# ADDENDUM No. 3

## RFP No. 24-19

### Miller Avenue Rehabilitation

#### Updated Due Date and Time: May 14, 2024 at 11:00 A.M. (local time)

SHEET No. **53 OF 131**  
DRAWING No. **2022034-53**  
SCALE PLAN: 1" = 20'  
PROFILE: 1" = 4'  
STA. 16+00 - STA. 18+69

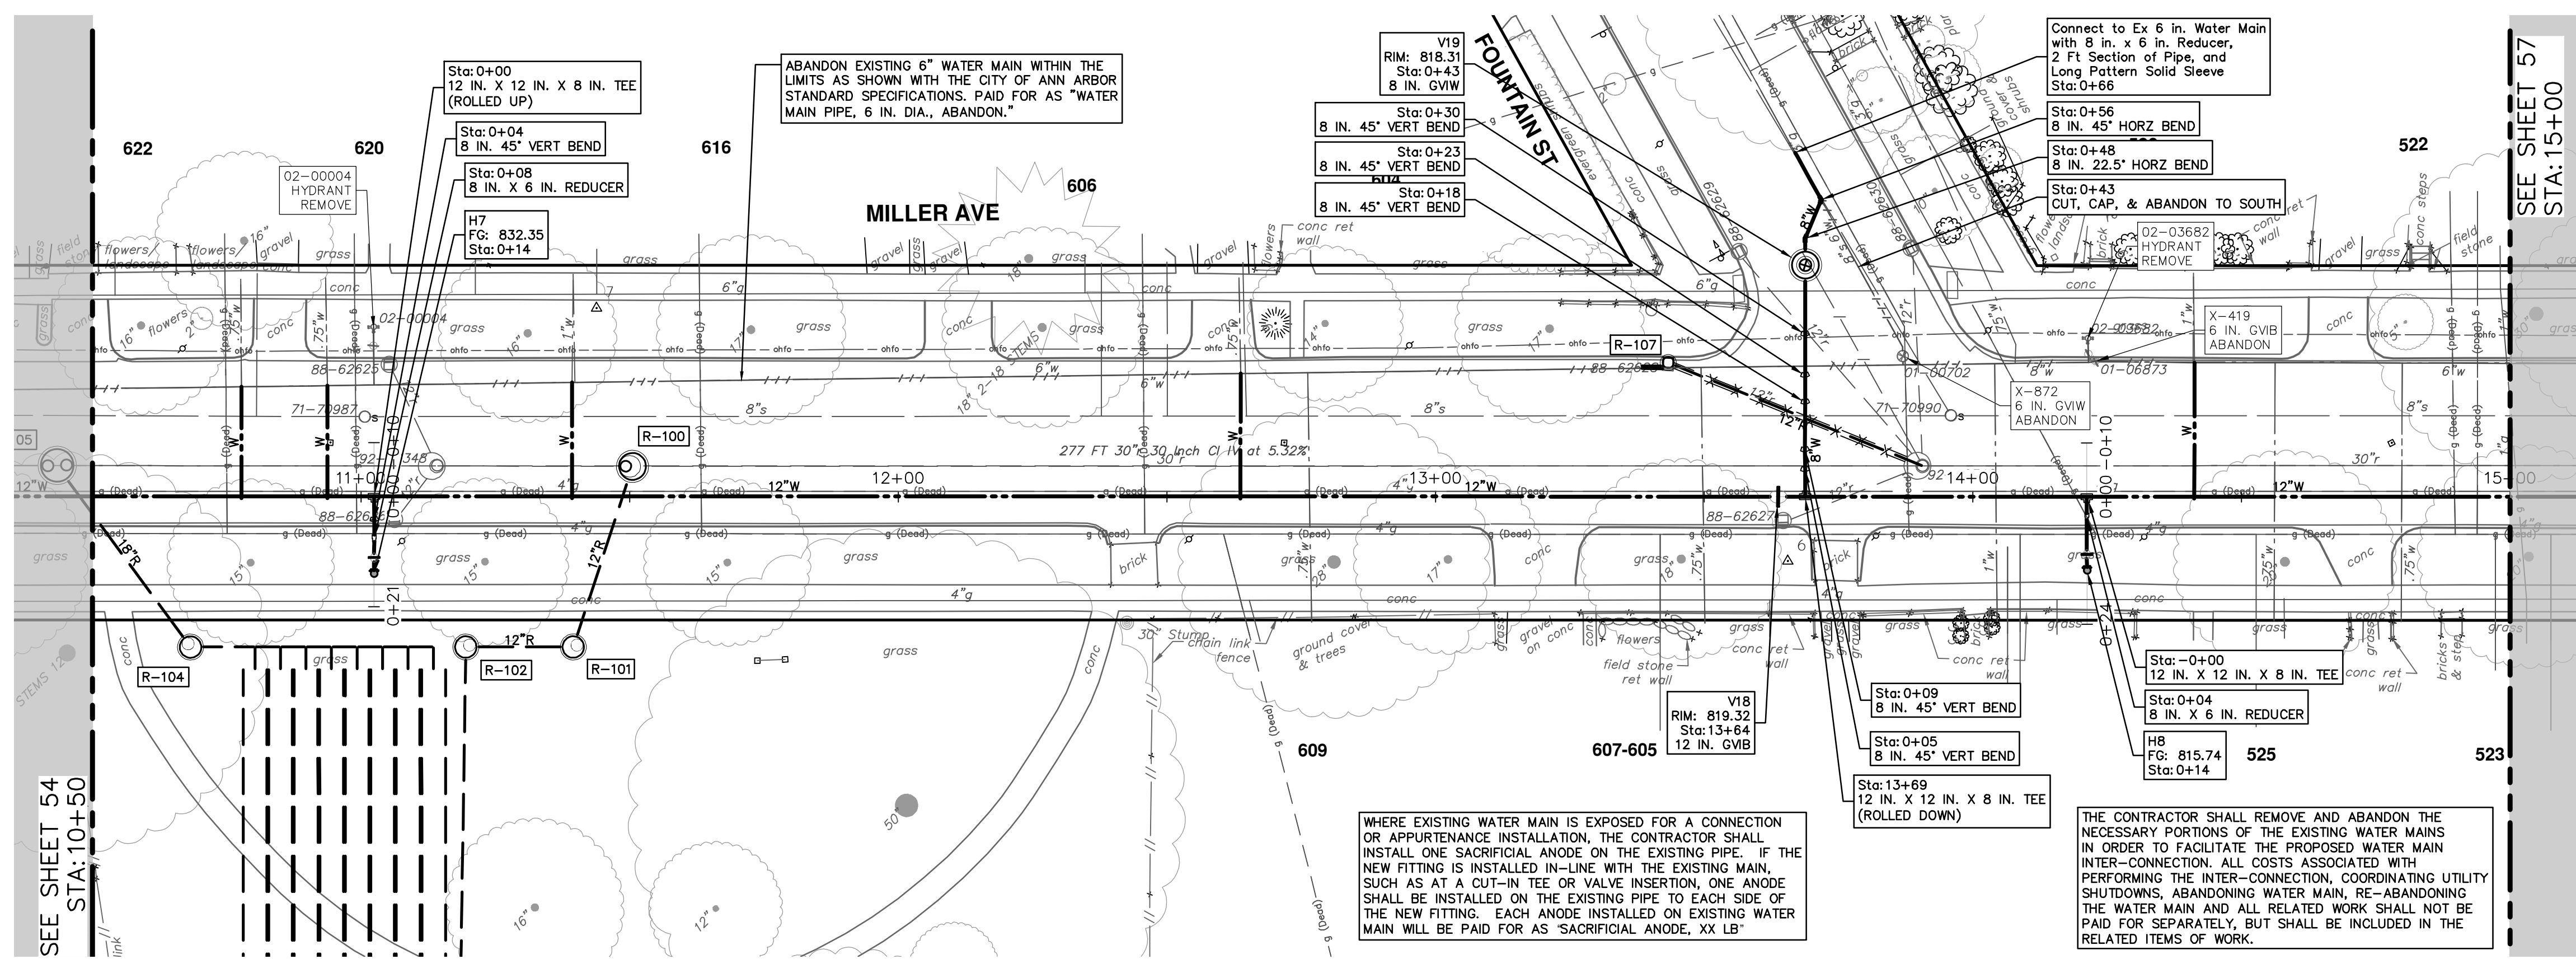
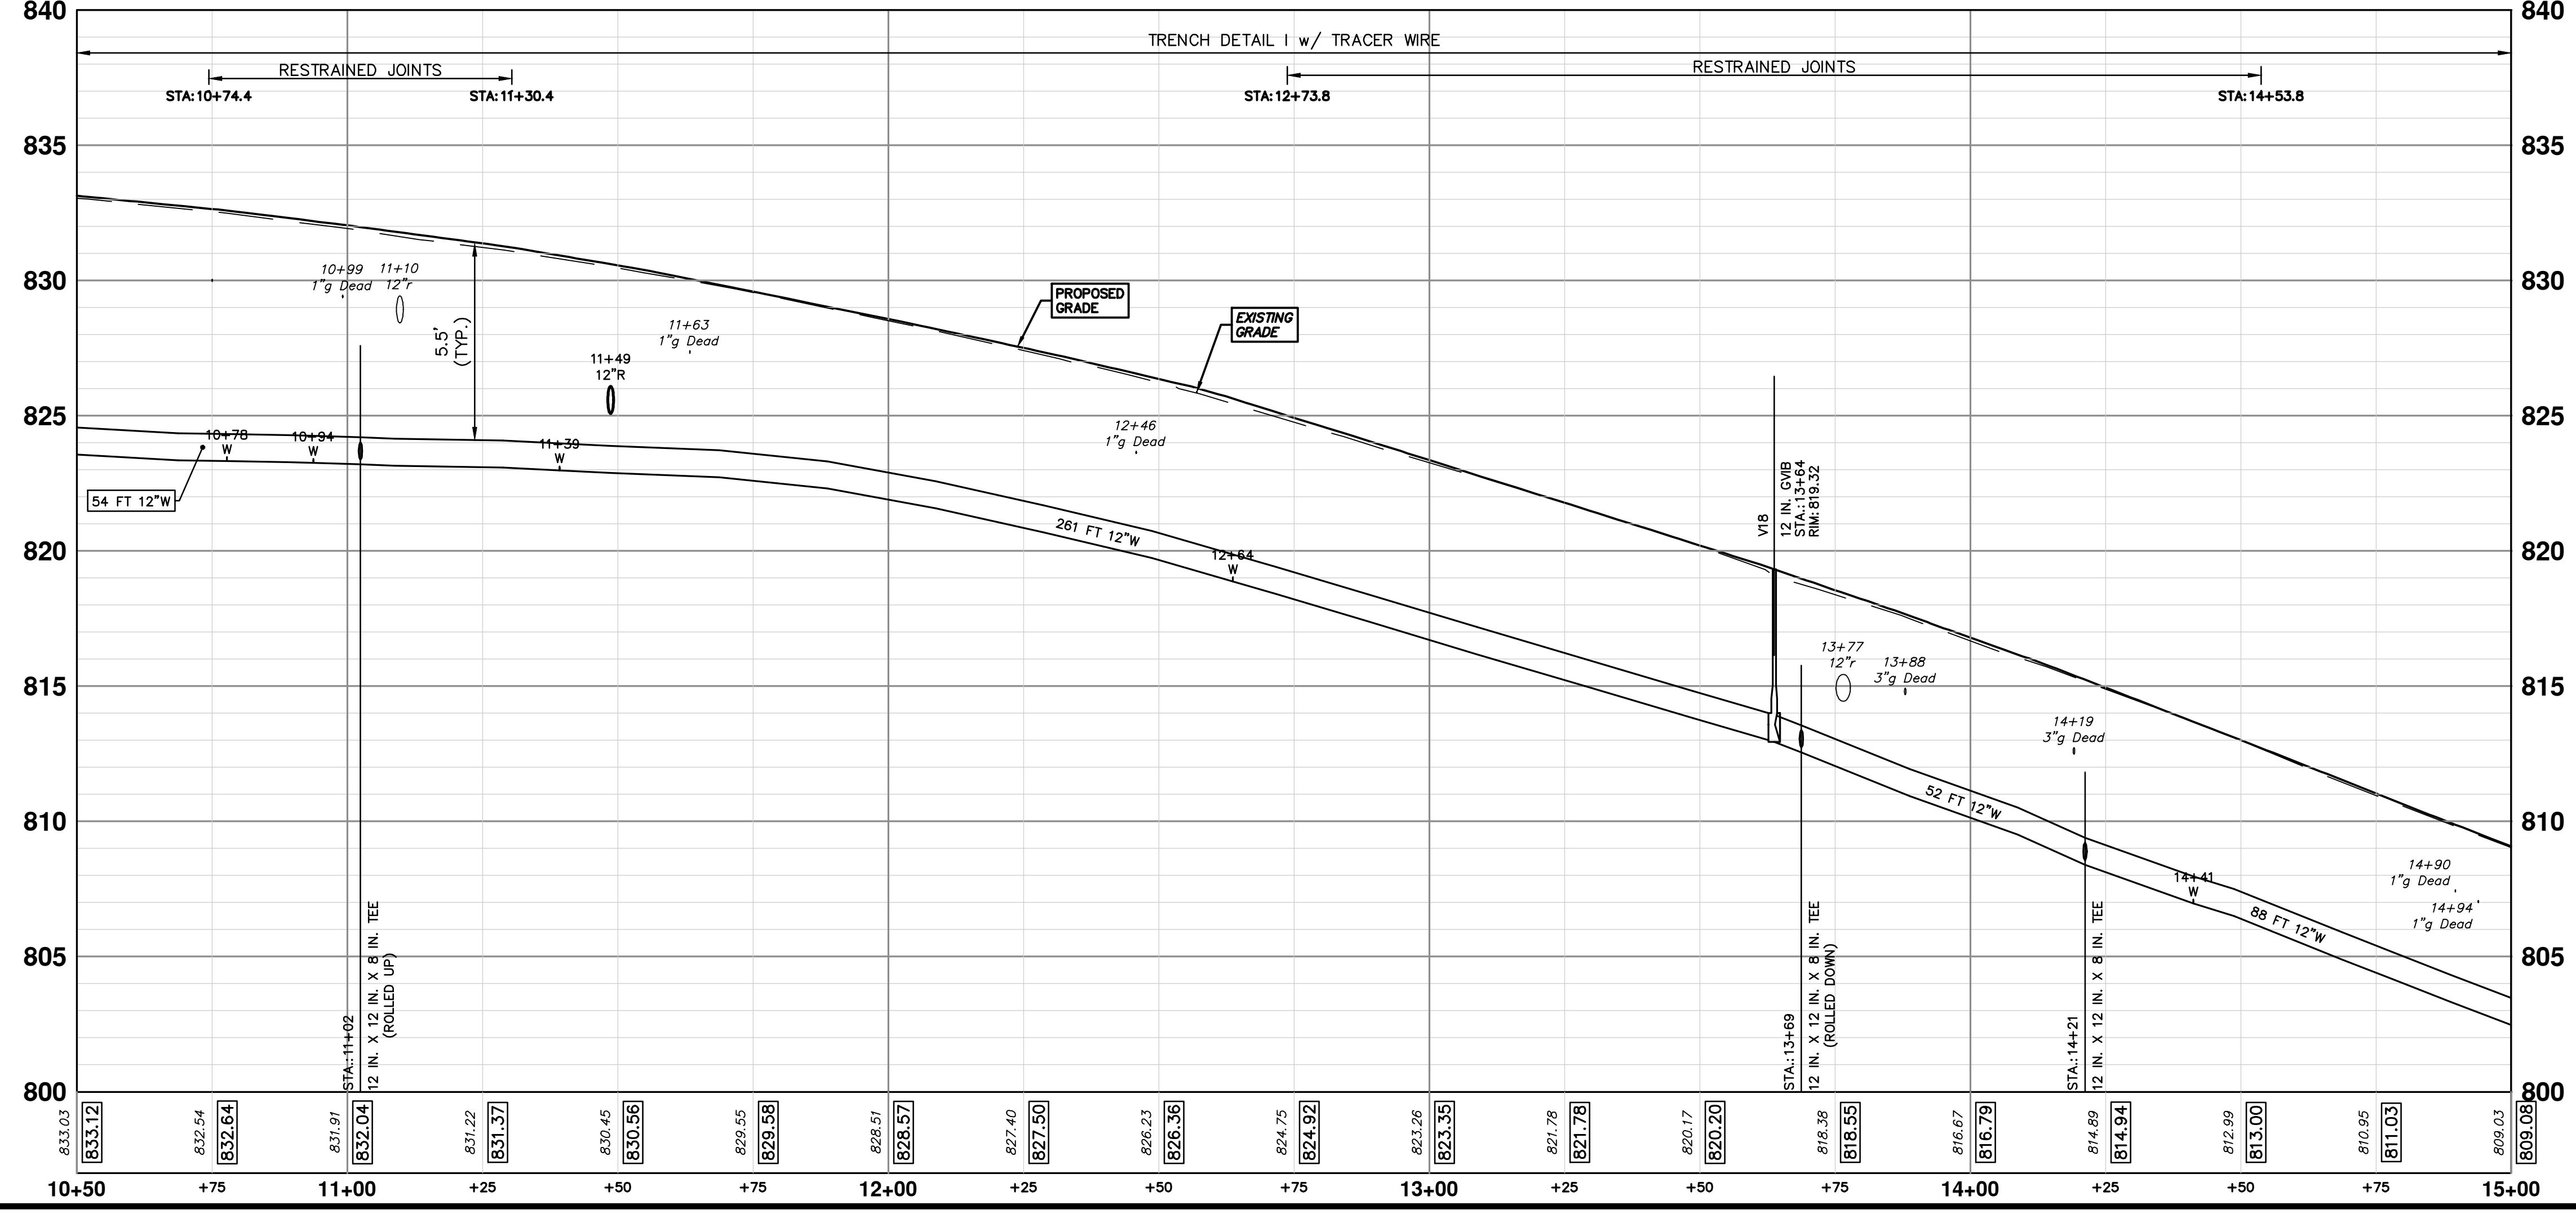
Question 3: Will the long side water service transfers be installed under the existing large diameter storm sewer in Miller, or will they go over the storm w/ insulation? As an example, please look at Sheet 54, Phase II (STA 07+33 to STA 10+50).

Answer 3: The large storm inverts seem to follow the new watermain inverts pretty close except from 10+00 to 11+00 where the storm inverts are less predictable. In this case, the City would want the long side services to go under the storm unless the watermain invert is over the top of storm, in which case wrapping it would be required.
